Project	<b>IEEE 802.16 Broadband Wireless Access Working Group</b> < <a href="http://ieee802.org/16">http://ieee802.org/16</a> >	
Title	<b>MS network entry Flow Charts for non-transparent RS with Distributed Scheduling</b>	
Date Submitted	<b>2007-07-05</b>	
Source(s)	Masato Okuda Fujitsu Laboratories LTD. Kamikodanaka 4-1-1, Nakahara-ku Kawasaki, Japan. 211-8588	Voice: +81-44-754-2811 E-mail: <a href="mailto:okuda@jp.fujitsu.com">okuda@jp.fujitsu.com</a>
Re:	IEEE802.16j-07/19, "Call for Technical Comments Regarding IEEE Project 802.16j"	
Abstract	This contribution proposes MS network entry procedure Flow Charts in non-transparent Relay Station systems.	
Purpose	To propose text to describe MS network entry in non-transparent Relay Station systems	
Notice	<i>This document does not represent the agreed views of the IEEE 802.16 Working Group or any of its subgroups. It represents only the views of the participants listed in the "Source(s)" field above. It is offered as a basis for discussion. It is not binding on the contributor(s), who reserve(s) the right to add, amend or withdraw material contained herein.</i>

# MS network entry Flow Charts for non-transparent RS with Distributed S

Figure-Y-1 MS CDMA ranging - RS

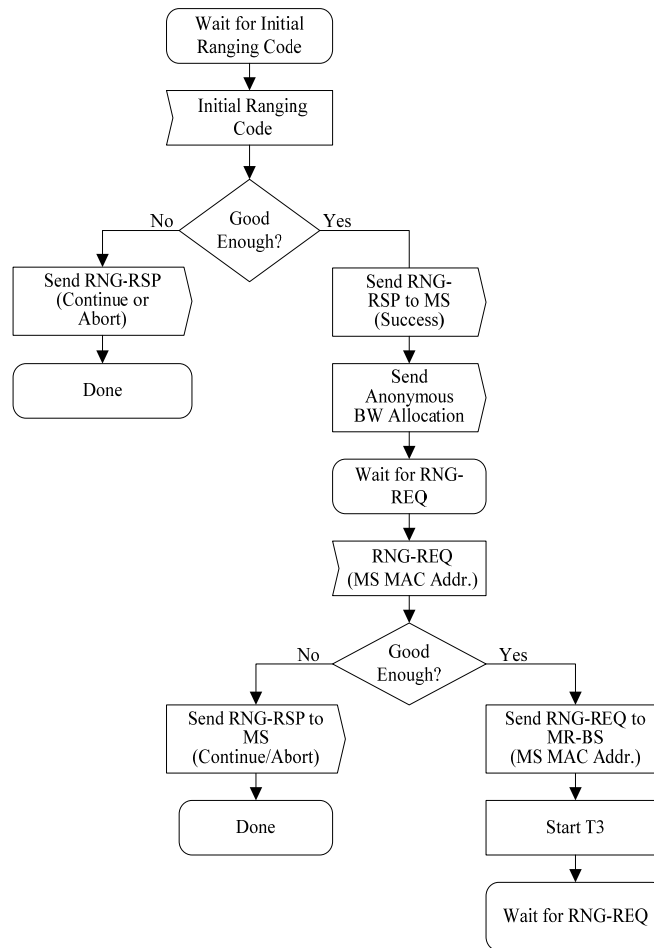
*Insert the following figures after the table 199b in the 6.3.9.16.2.2 (Non-transparent RS with Distributed Scheduling):*
